Office Action Summary	Application No. 10/709,134	Applicant(s) HARMS, ROBERT E.	
	Examiner VICTOR K. HWANG	Art Unit 3764

DETAILED ACTION

BE 201, 201B & BE 227B DUMBBELL RACKS

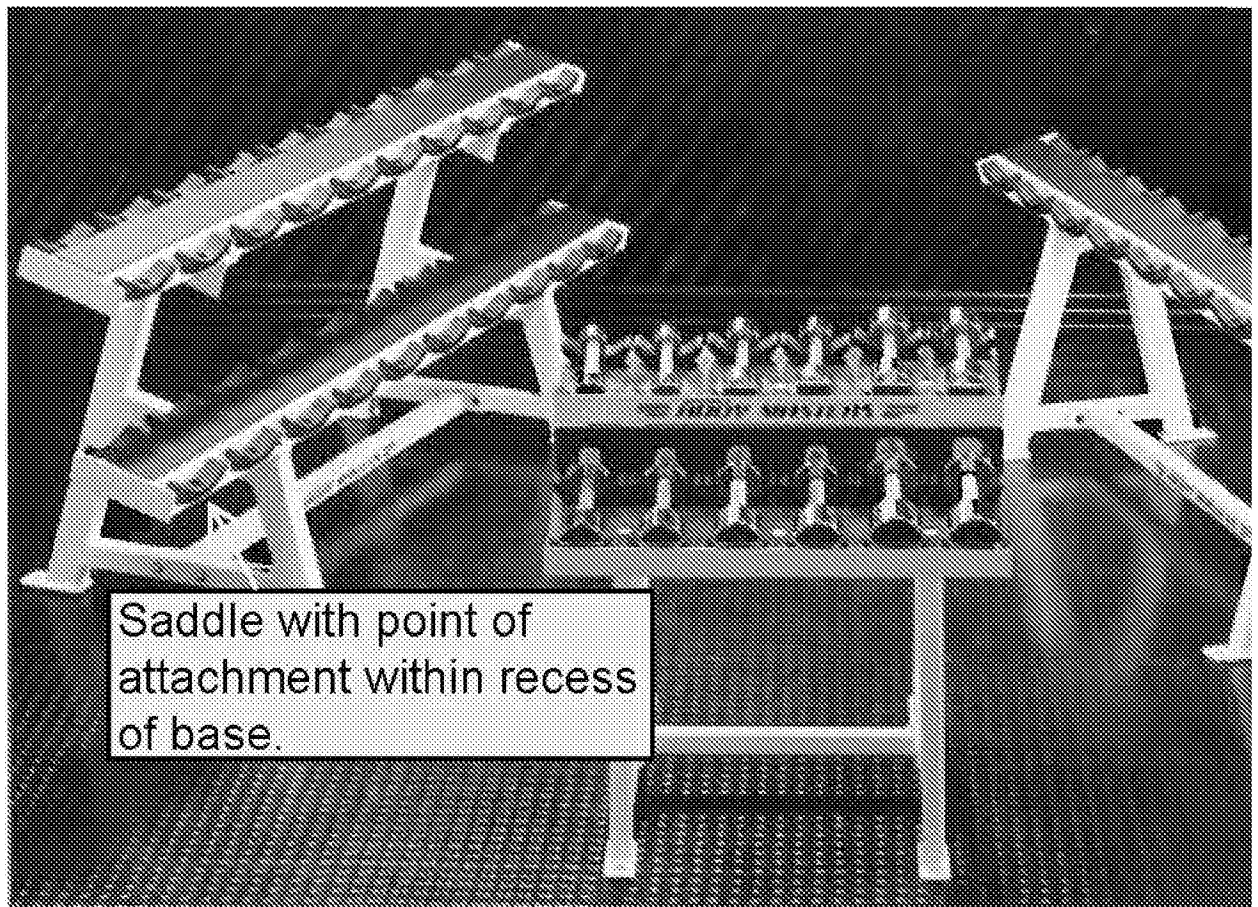
Bodymasters, enlarged below, discloses a typical dumbbell rack having a plurality of curved saddles arranged in pairs to support dumbbells. A point of attachment can be seen in the base of the saddle and appears to be within a recess of the base. One of ordinary skill in the exercise art would recognize that a bolt or rivet is located within the recess of the base of the saddle and secures the saddle to the angle iron of the rack frame, since Applicant has disclosed that it is old to use a bolt and nut to secure a saddle to an angle iron of a dumbbell rack.

Bodymasters discloses a typical dumbbell rack having a plurality of curved saddles arranged in pairs to support dumbbells. A point of attachment can be seen in the base of the saddle and appears to be within a recess of the base. It would have been obvious to one having ordinary skill in the art at the time the invention was made that a bolt is located within the recess of the base of the saddle of *Bodymasters* to secure the saddle to the angle iron of the rack frame,
